MIL-D-81609C(AS)
 AMENDMENT 1
 10 SEPTEMBER 1986

MILITARY SPECIFICATION
 DETECTING SET, MAGNETIC AN/ASQ-81(V)

This amendment forms a part of MIL-D-81609C(AS), dated 23 July 1981, and is approved for use by the Naval Air Systems Command, Department of the Navy, and is available for use by all Departments and Agencies of the Department of Defense.

*FIGURE 4. RANDOM VIBRATION SPECTRUM

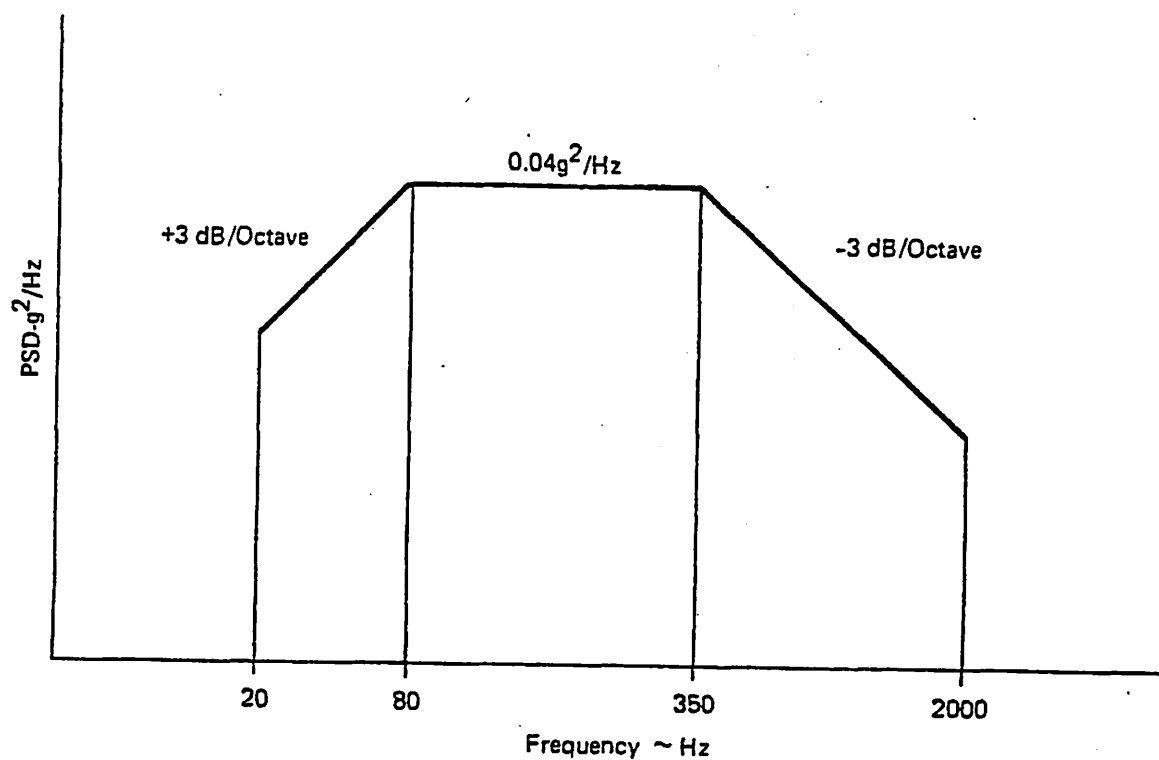
*4.4.1.3 Manufacturing Screening - Each equipment shall undergo 10 minutes of random vibration per Figure 4. The vibration shall be applied perpendicular to the plane of the printed circuit boards in a minimum of two axis for all electronic modules, SRA's, and WRA's including SRA's on the reeling machine. If different planes exist, the vibration shall be applied to each axis for 10 minutes. After completion of random vibration, each module, SRA and WRA shall be examined carefully to determine that materials and workmanship

*Figure 4 - Add Figure 4.
